SUP 167/25

SANTIAGO/Rosalía de Castro AD (LEST).- Compliance works on apron P1.

Until 02 October 2026 (estimated) the new configuration of apron P1 will be carried out through the modification of its markings.

- ZONA DE TRABAJO // WORKING AREA
- LÍMITE DE PLATAFORMA
- ZONA NO VISIBLE DESDE TWR // AREA NOT VISIBLE FROM TWR

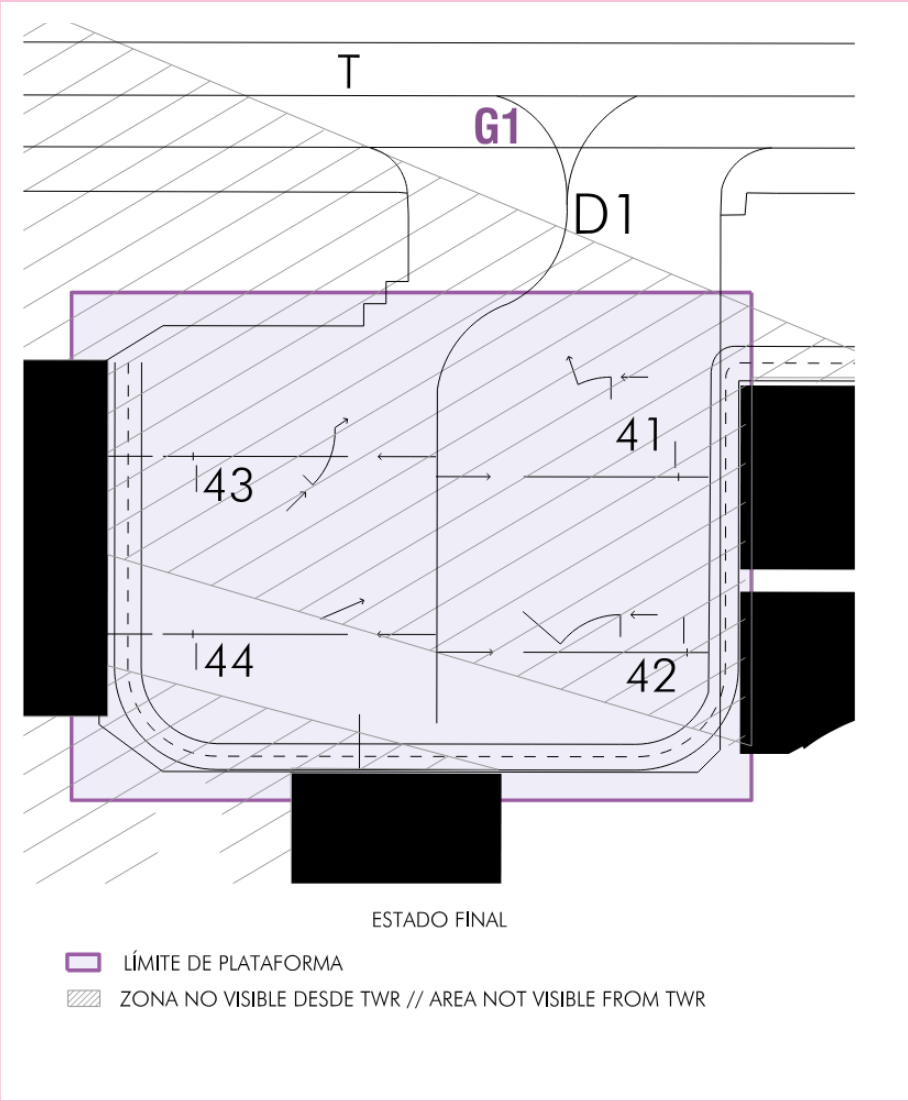
The works, consisting of blasting and painting, will be carried out in a single phase during which apron P1 and TWY D1 will remain closed.

The works will take place within apron P1, which will be closed and lit.

All work areas will be duly marked and lit. Caution is recommended due to the presence of personnel and machinery.

In the event that LVP are activated, the works will be suspended and workers and machinery removed, with the work area remaining closed and lit.

Once the works have been completed, the configuration of apron P1 will be as follows:

- TWY D1 will be reclassified as code letter C-II (20.0 Local regulations, 3.3 taxiing restrictions chart B taxiing).
- The characteristics of PRKG 41, 42, 43 and 44 will be as follows:
